OUT2 is connected using Inductors to **OUT1**

cadence _ # × (Operating MODE)

OUT2 is connected using Inductors to OUT1/ Result

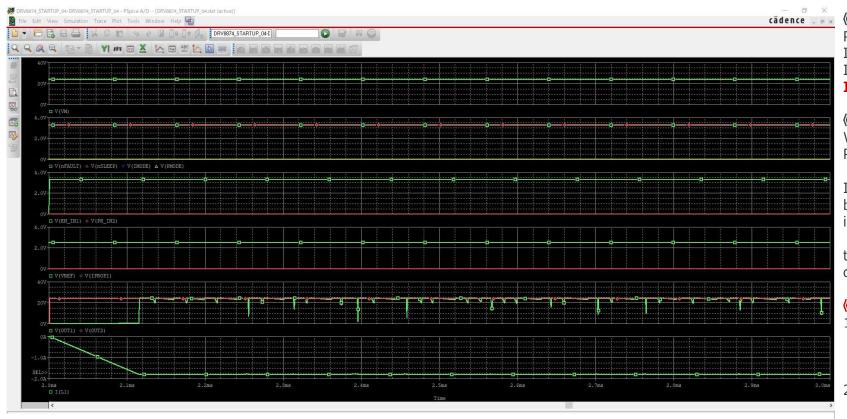
Wave form : $0ms \sim 4ms$. PH/EN is operated from 2ms.

OUT2 is connected using Inductors to **OUT1**/ Result

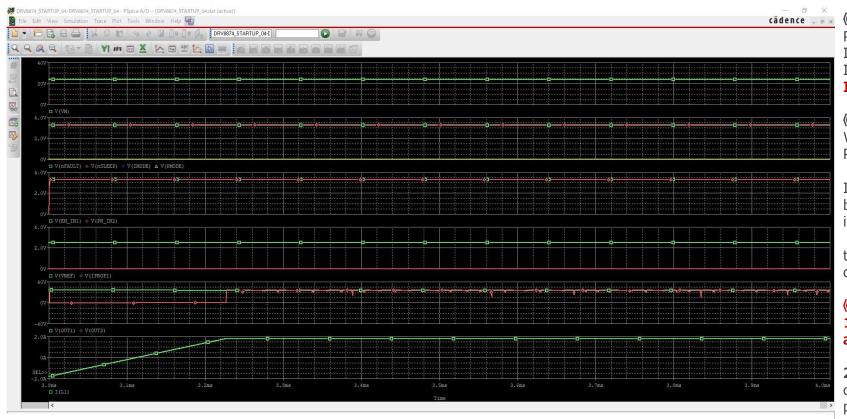
Wave form: 2ms ~ 3ms. PH/EN is operated from 2ms.

Itrip setting is 1A. but the current(from out2 to out1) is about 1.8A.

the current(from out2 to out1) is different from Itrip setting.

- 1. Is this simulation result is correct? Would you tell me the problems about the design.
- 2. Why is it different from the current(from out2 to out1) and Itrip setting?
